MEETING MINUTES

Tuesday, October 7, 2014
Planning and Economic Development Board
155 Village Street
Medway, MA 02053

MAYLAND WOODS SUBDIVISION

FOX RUN FARM/MORNINGSIDE DRIVE

ROADWAY
AS-BUILT PLAN
IN
MORNINGSIDE DRIVE
MEDWAY
MASSACHUSETTS
DATE: SEPTEMBER 26, 2014

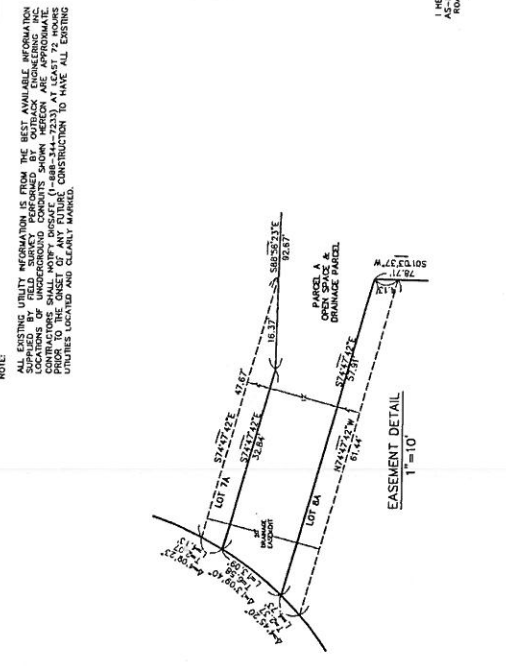
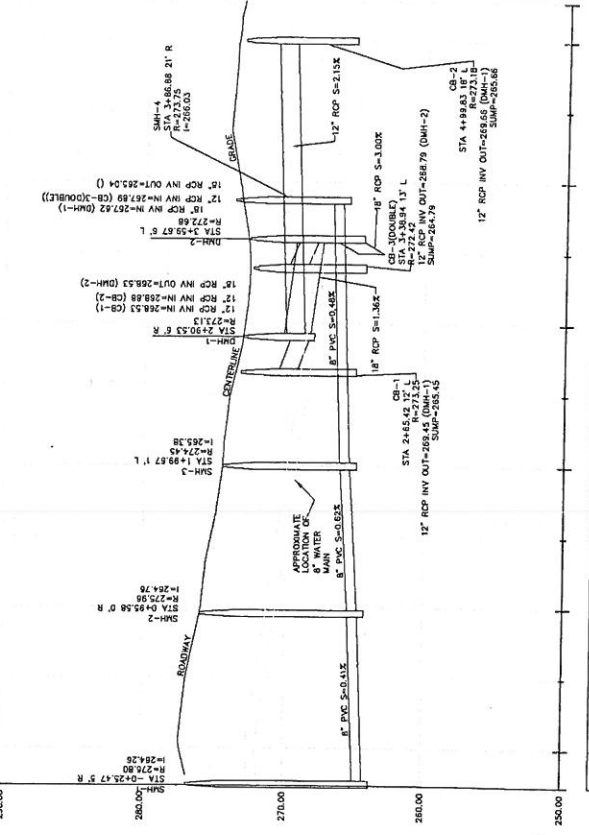
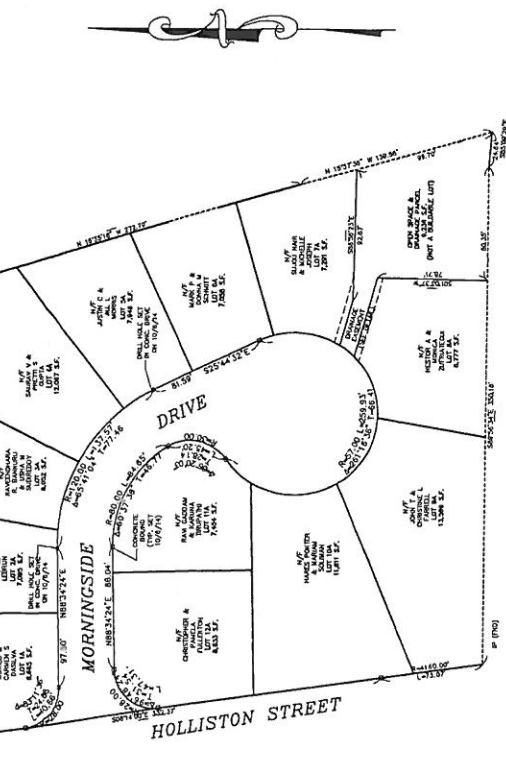
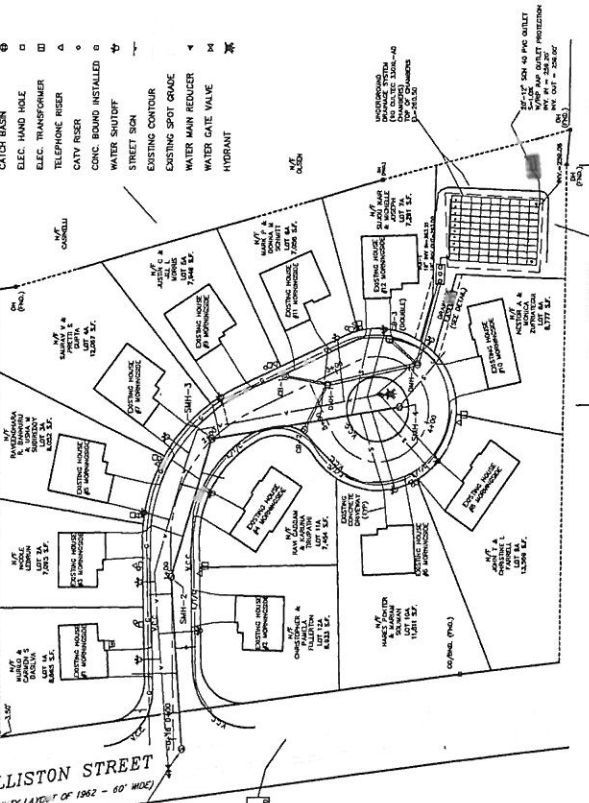
Tetra Tech (TT) is in receipt of plan entitled "Road/Drainage As-Built Plan, Morningside Drive in Medway, Massachusetts", dated September 26, 2014, prepared by Outback Engineering Inc. The As-Built Plan was reviewed for conformance with the Town of Medway Planning Board Rules and Regulations (Chapter 100). The following list represents our comments regarding the plans.

1. The As-Built Plan shall be stamped by a professional land surveyor registered in the Commonwealth of Massachusetts. (Ch. 100 §6.7.3)
2. The drainage easement located adjacent to the Underground Detention System should be labeled. (Ch. 100 §6.7.4.b)
 - TT 10/7/14 Update: This item has been addressed to our satisfaction.
3. Curbing type not labeled for the vertical granite curb on the radii at the entrance to the subdivision. (Ch. 100 §6.7.4.e)
 - TT 10/7/14 Update: An incorrect label has been placed on the curb radii at the entrance to the roadway. It should read "V.G.C." on both radii.

4. The plan should include the dates in which monumentation was set. (Ch. 100 §6.7.4.f)
5. The benchmark labeled “BENCHMARK: EXIST. SMH RIM” in Holliston Street is not pointing to a sewer manhole. (Ch. 100 §6.7.4.f)

- TT 10/7/14 Update: This item has been addressed to our satisfaction.
6. The line work for the spare conduit, electric/telephone/cable tv, gas and fire alarm system are not shown in the plan view. The symbol key should not include a light post since there are no light posts included in the subdivision. There are also several spelling errors in the symbol key (drain manhole and elec. hand hole). The symbol for the water gate at the connection to the water main in Holliston Street is not included in the symbol key. (Ch. 100 §6.7.4.g)

8. The plan should include a “DIG-SAFE” notification as a warning before future excavation of the street. (Ch. 100 §6.7.4.k)
 - TT 10/7/14 Update: This item has been addressed to our satisfaction.

10. The note at the entrance to the subdivision referring to “Existing U.P. to be relocated” should be removed from the plan since the pole has been relocated in the as-built condition.
 - TT 10/7/14 Update: The relocated utility pole should be shown on the plan.
11. Text is overlapping lines and other text in much of the plan and is difficult to read.
 - TT 10/7/14 Update: This item has been addressed to our satisfaction.

12. Symbols should be consistent in size and shape to what is shown on the plan.

TT is in receipt of the revised as-built plan entitled "Road/Drainage As-Built Plan, Morningside Drive in Medway, Massachusetts", dated September 26, 2014, revised October 6, 2014 prepared by Outback Engineering Inc. The items have been updated as shown below.

- TT 10/7/14 Update: The above-mentioned lines have been placed in the plan but the electric/telephone/cable tv services which cross the road to service the units on the eastern side of the roadway should be shown. Edits to the symbol key have been addressed to our satisfaction.

View From Inside Vehicle

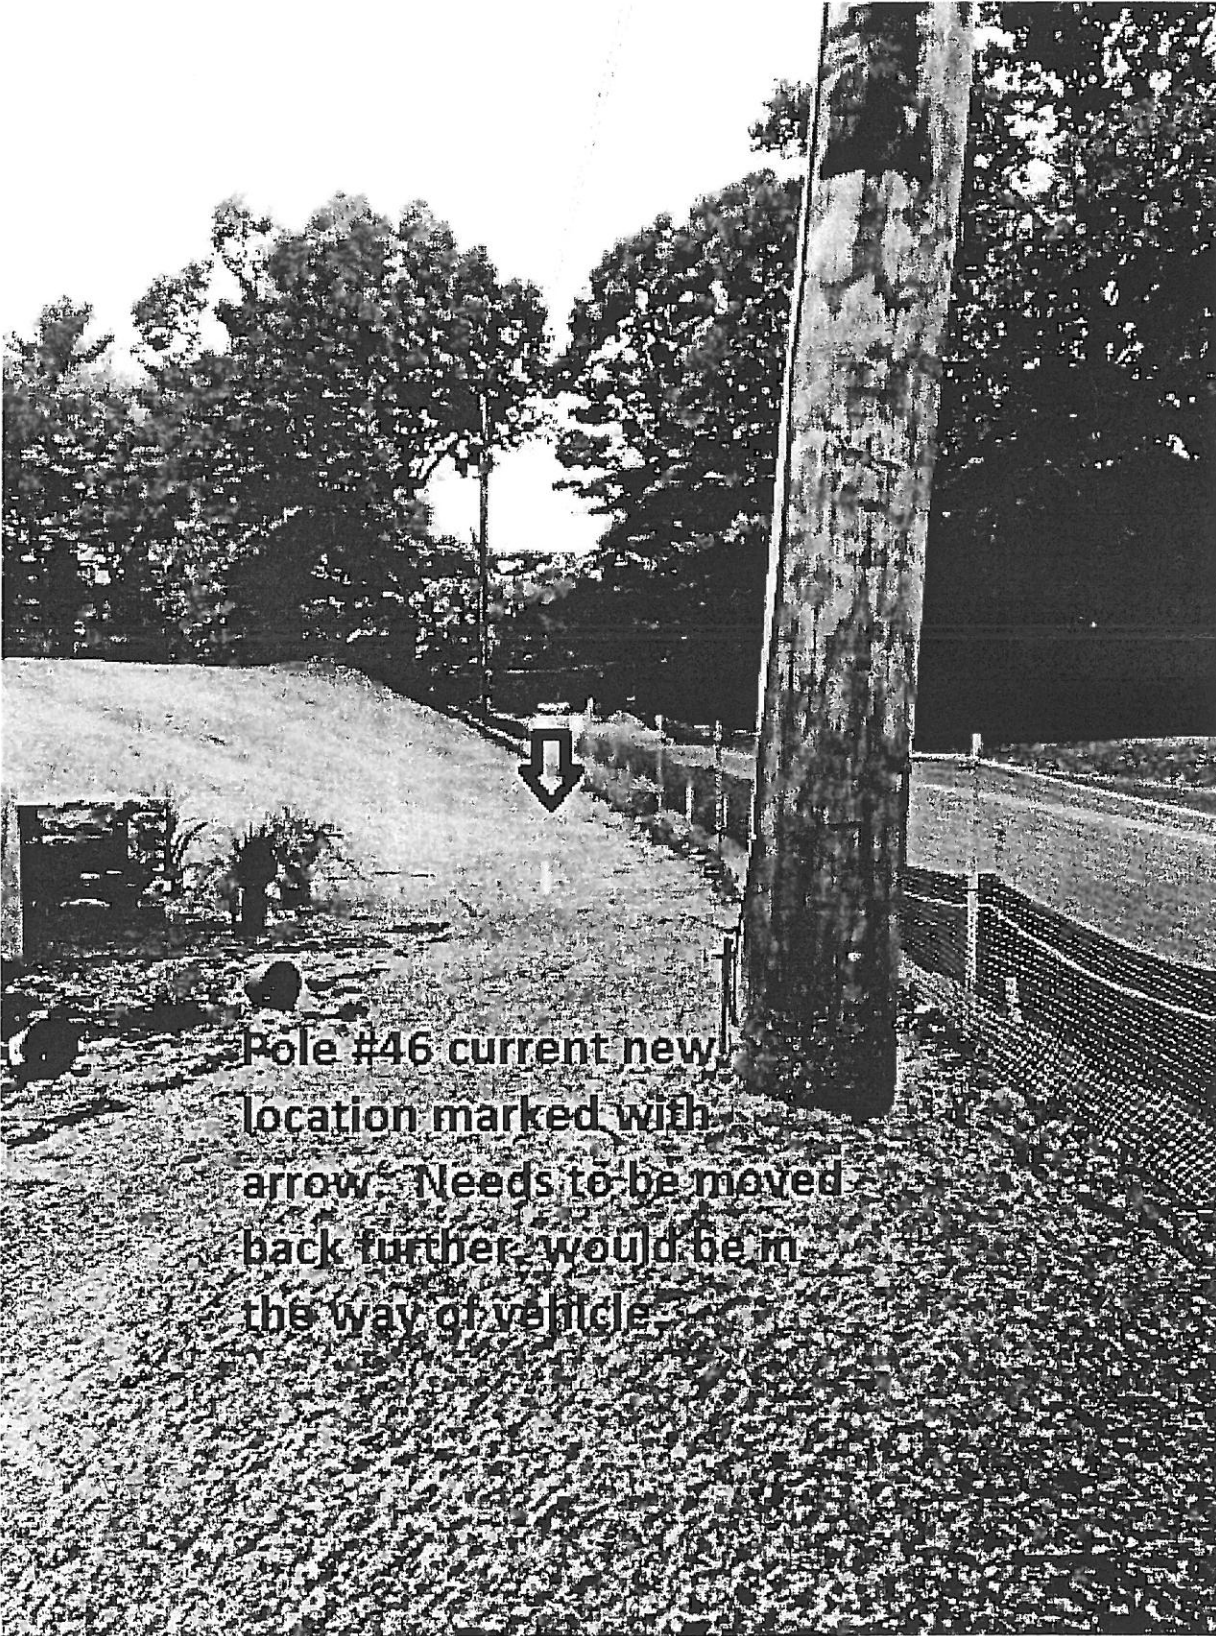
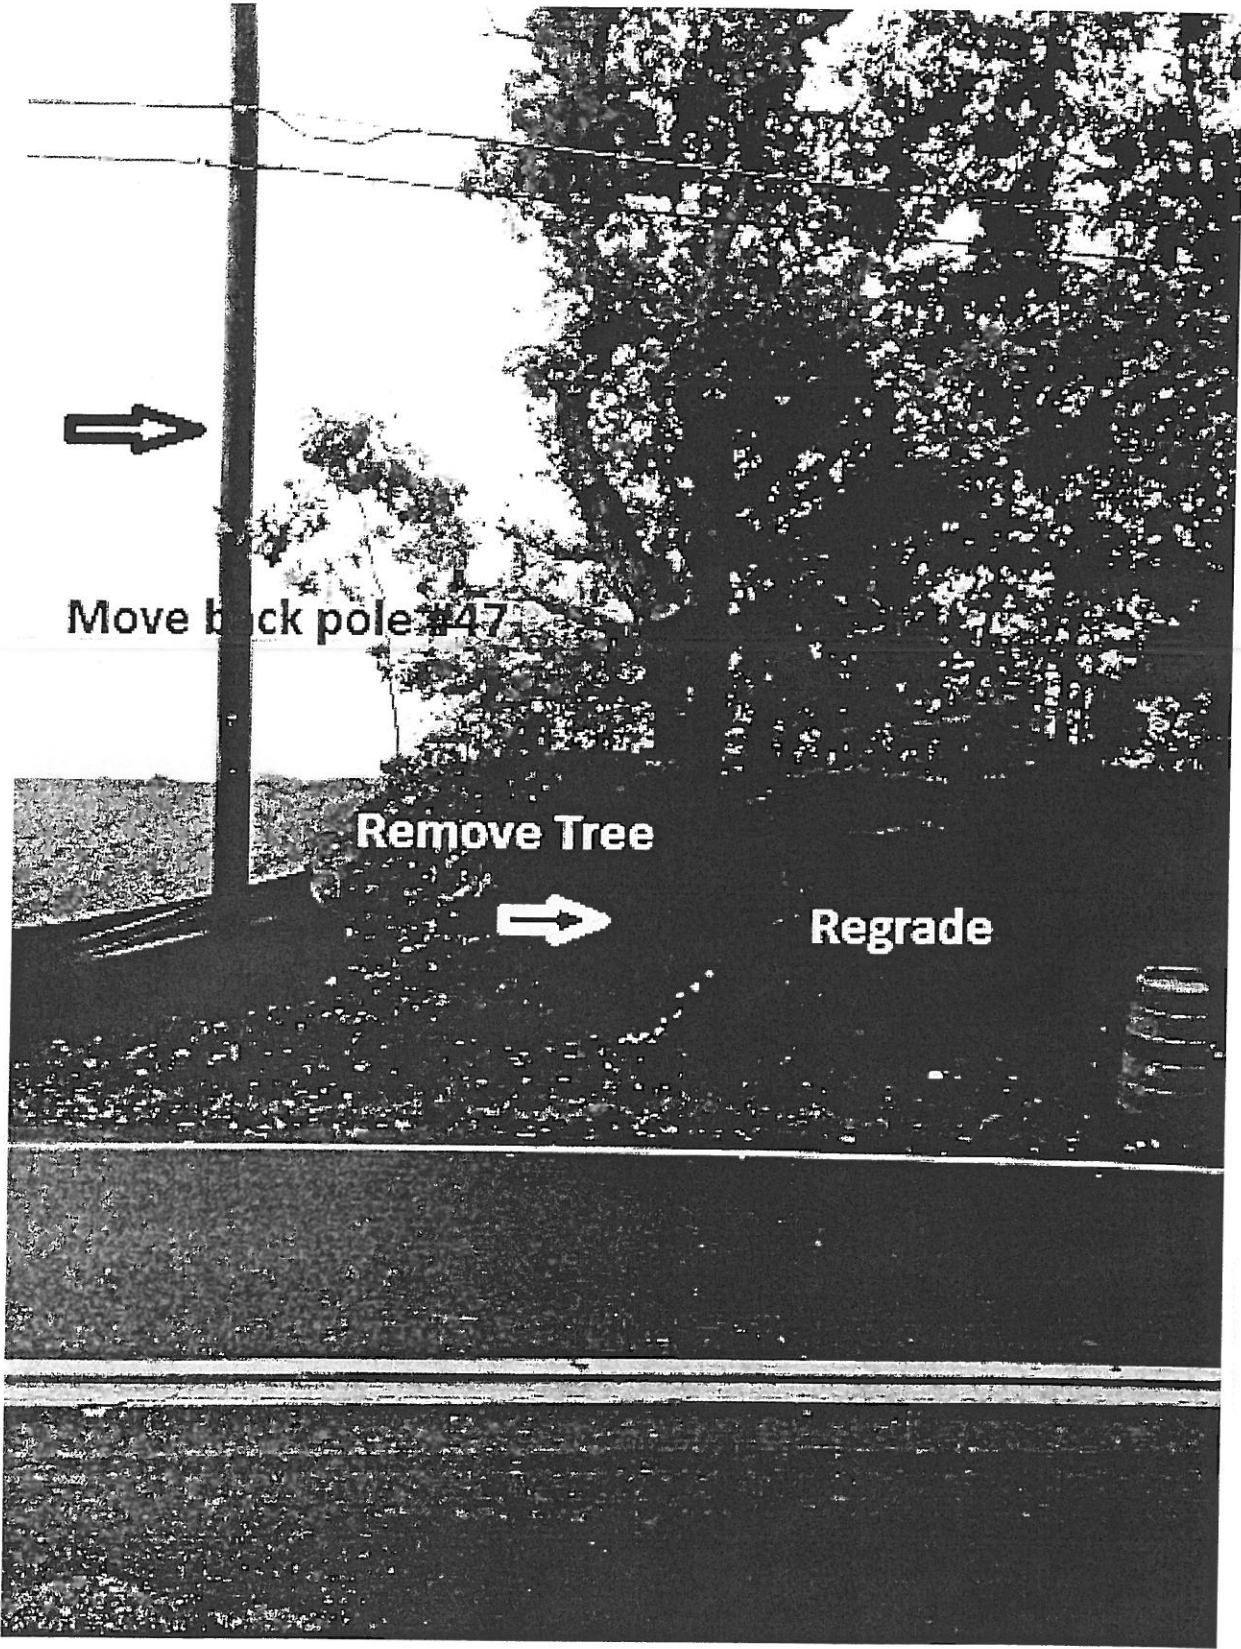
While checking the construction site I noticed a safety concern when exiting the North entrance/exit. There is not a proper sight line on the North side. While stopped looking North, Verizon pole #46 is presently in a bad location. However the new location that is marked with a white stick would put the pole directly in the exiting driver's line of sight. Pole #46 should be moved further back (west) at least five feet from the new location. Verizon Pole #47 is also in the sight line and should also be moved back (westerly).

Per my previous recommendation and in compliance with the approved Millstone Village Plan, the developer properly graded and removed any and all shrubs that would have restricted the sight line. However, just after Verizon pole #47 the grade of the land along with another large tree and other small trees interfere with the sight line.

It would be my recommendation, that both poles be moved along with the removal of the large tree located near pole #47. The grading should be continued from the first Verizon pole #46 to approximately 30 feet north of Verizon pole #46. These revisions would allow for a safer egress onto Winthrop Street from the development.

Pole #46 current new location marked with arrow. Needs to be moved back further, would be in the way of vehicle.

Move back pole #47

Remove Tree
